Informal document GRSP-63-32
(63rd GRSP, 14 - 18 May 2018,
agenda item 14)

UN-Regulation No. 80

Additional Information to GRSP-62-35

179421190_002 – Seat A

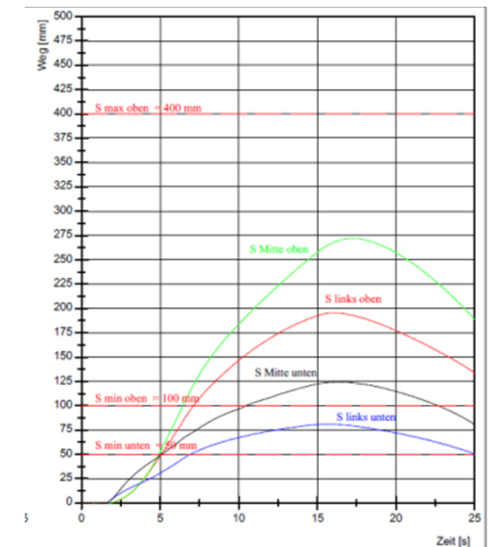
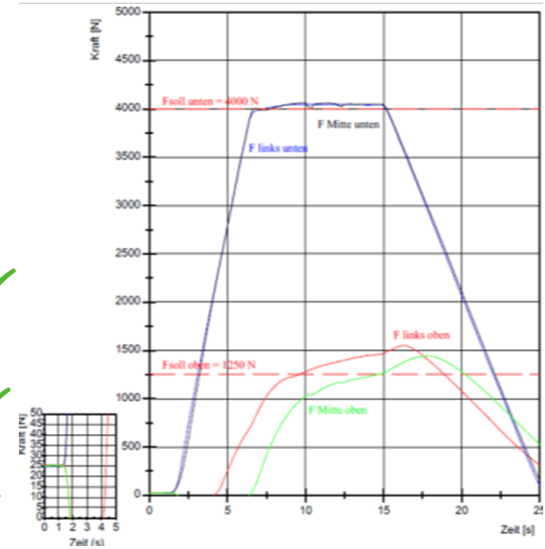
- Tested according to R80 – Appendix 5
- Observations:
 - Seat stays in place, no failure
 - The maximum displacement at F_1 is below the threshold of 400mm
 - The minimum displacement at F_1/ F_2 is above the threshold of 100/50mm

R80-1-1-01 - Seat A

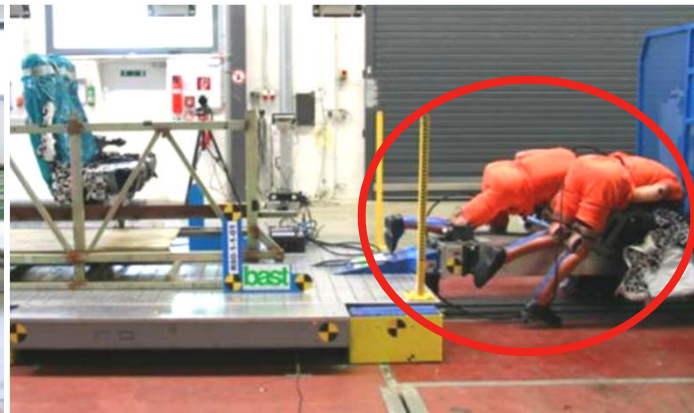
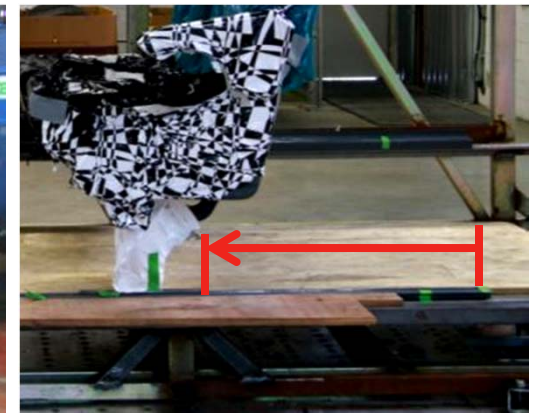
- Tested according to R80 – Appendix 1, Test 1 (unbelted)
 - Observations:
 - Auxiliary seat slides 600mm (but still in seat track)
 - Test seat slides without any load of the dummies completely out of the seat track
- seat mountings are not strong enough to hold the seat in place
- Occupants are not restrained by the test seat
- Dummy values are below the thresholds but serious injuries are likely
